**Final Regulatory Impact Analysis and
Summary and Analysis of Comments**

Control of Vehicular Evaporative Emissions

February 1993

Figure 2-1

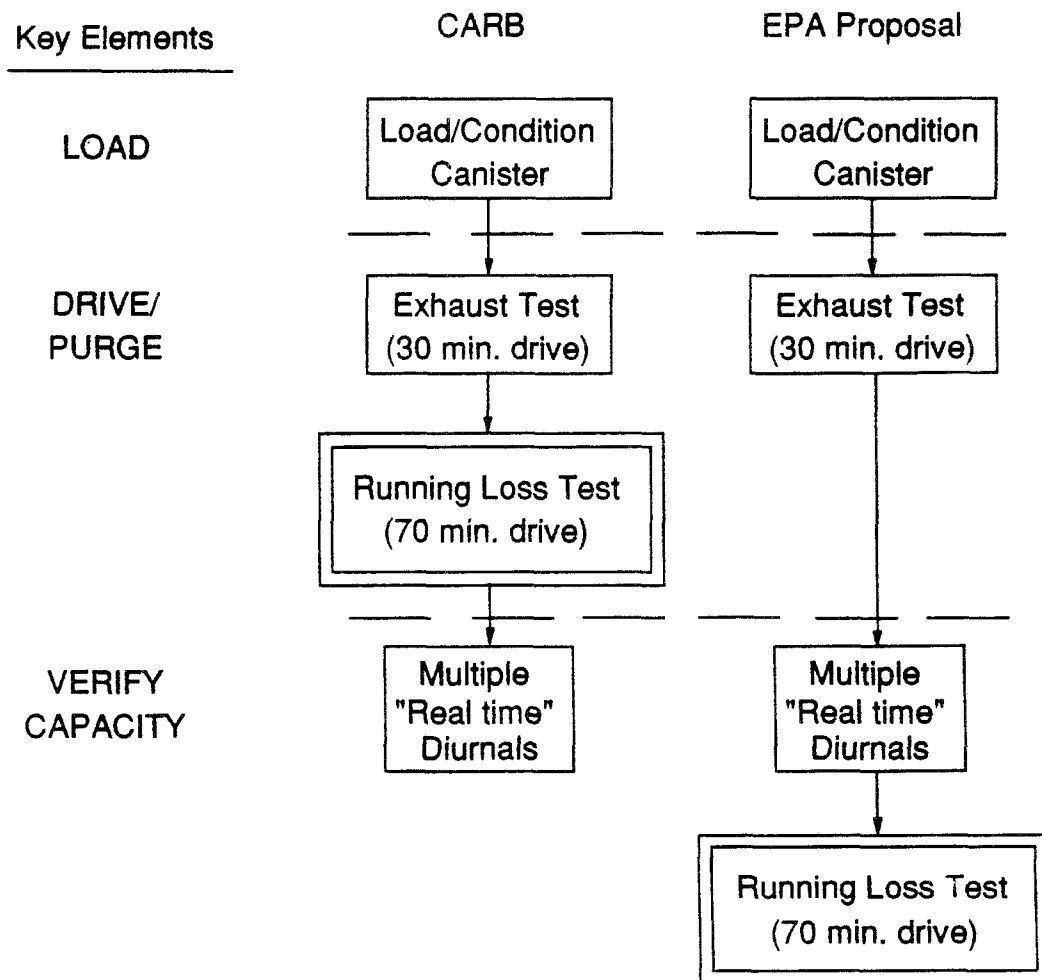
Manufacturers objected to EPA's proposal, arguing primarily that the proposed test sequence, compared to in-use driving patterns, represented a rare and rather extreme scenario of vehicle operation. Manufacturers claimed that because the

specific drive-park sequence represented in the test would so rarely happen in real driving, EPA's approach was invalid. They reinforced their position with the observation that EPA's MOBILE model estimates that vehicles from the in-use fleet average approximately 30 miles (48 km) of driving per day, much more than the 11 miles (18 km) of driving for the exhaust emission test.⁶ Most auto manufacturers recommended that EPA adopt CARB's test procedure.

Figure 2-2

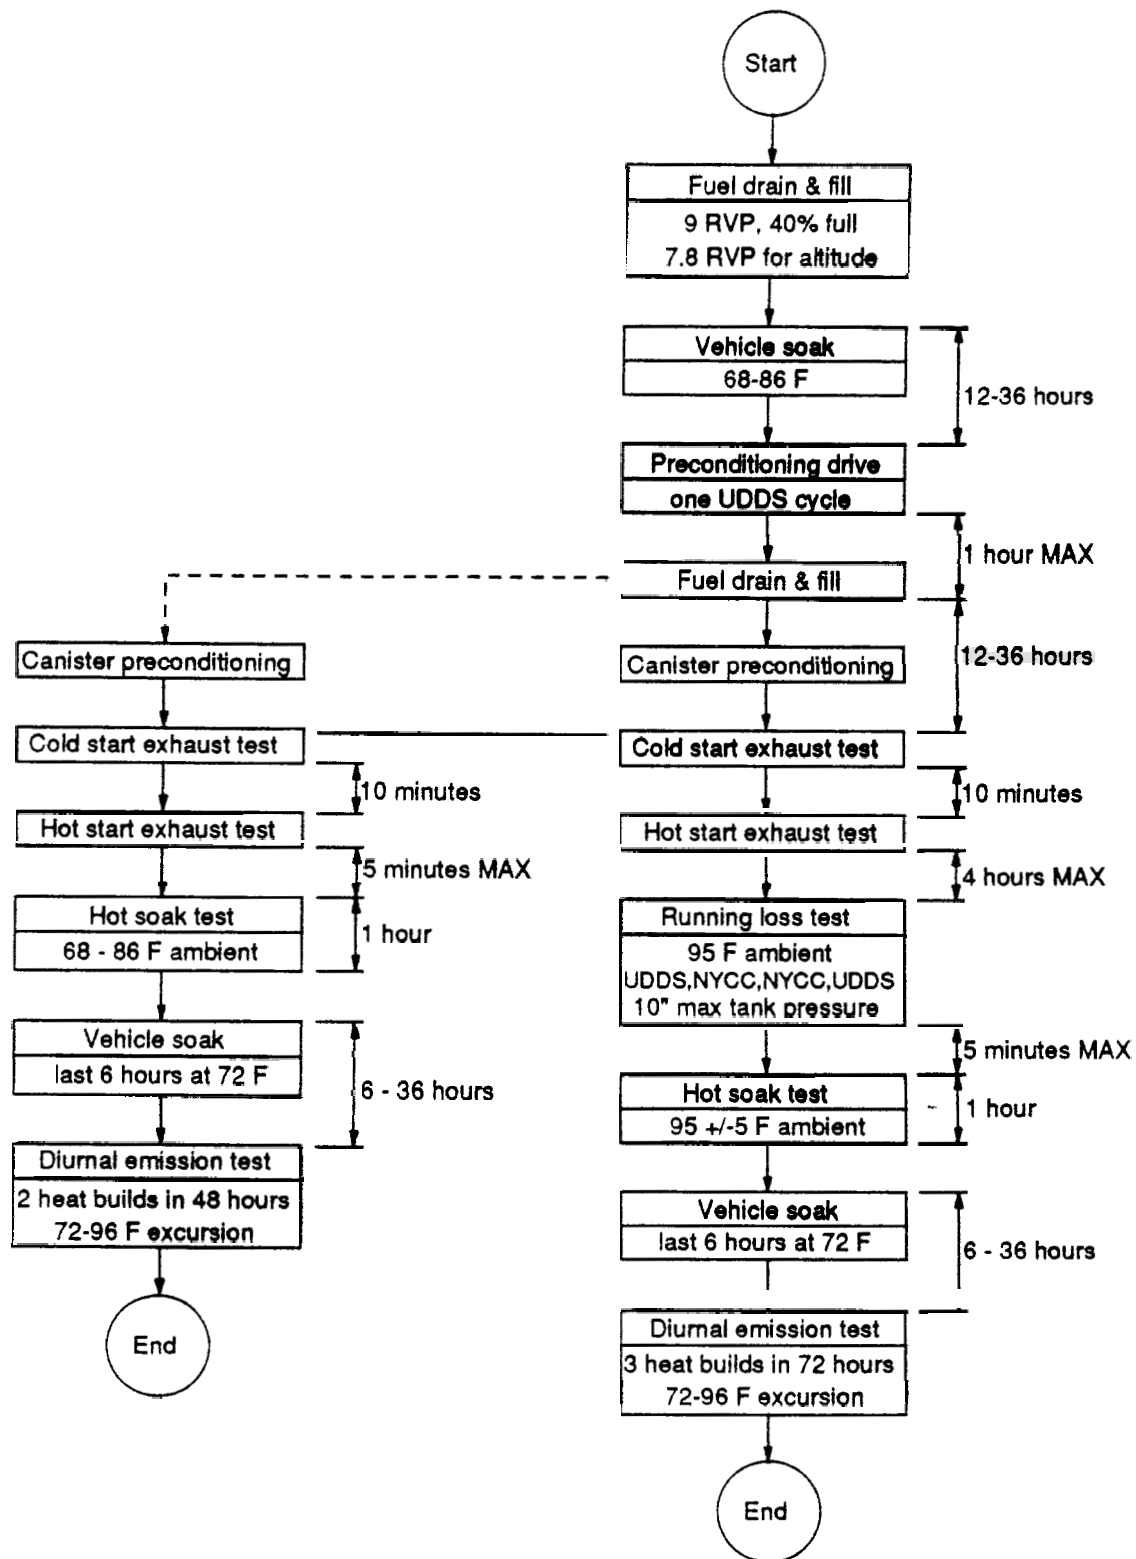
Ford and Chrysler came forward with nearly identical approaches for a potential compromise, consistent with CARB's proposed option for a special two-diurnal test to ensure sufficient purge in short-trip driving patterns.^{8,9} Ford and Chrysler recommended that EPA finalize CARB's adopted procedure, with minor modifications, for certification testing. For recall testing, they suggested an abbreviated test, consisting of the preconditioning and exhaust emission test, followed by a moderate-temperature hot soak test, and two diurnal heat builds. Since Ford and Chrysler offered no explanation of the differences for recall and certification testing, EPA understands that they were merely responding to EPA's desire to adopt an enforceable in-use test that would ensure adequate purge rates. The standard for recall testing would be 2.5 grams for vehicles with fuel tank capacity less than 30 gallons (110 liters), and would allow for exclusion of nonfuel emissions. Vehicles with larger fuel tanks would be subject to a 3-gram standard. No explanation of the basis for these relaxed standards was stated.

objective of ensuring proper purge without requiring additional design modifications (such as increased canister size). Figure 2-2 shows EPA's approach to designing an evaporative test based on the Ford and Chrysler comments. Also, EPA believes that the vehicle hardware that would be needed to meet the test requirements proposed in EPA's January 1990 NPRM (e.g., canisters, purge valves) will be sufficient to meet the requirements of the supplemental test.

The supplemental test procedure would not in itself provide assurance that a vehicle could meet all requirements of the longer three-diurnal test. For example, there is no measurement of running losses and the final diurnal heat build is omitted in the supplemental test. Thus, the supplemental procedure is not a replacement for the three-diurnal test. However, the opportunity for EPA to run the longer test, in both confirmatory certification and in-use testing, provides the necessary assurance that vehicle designs will achieve optimum control.
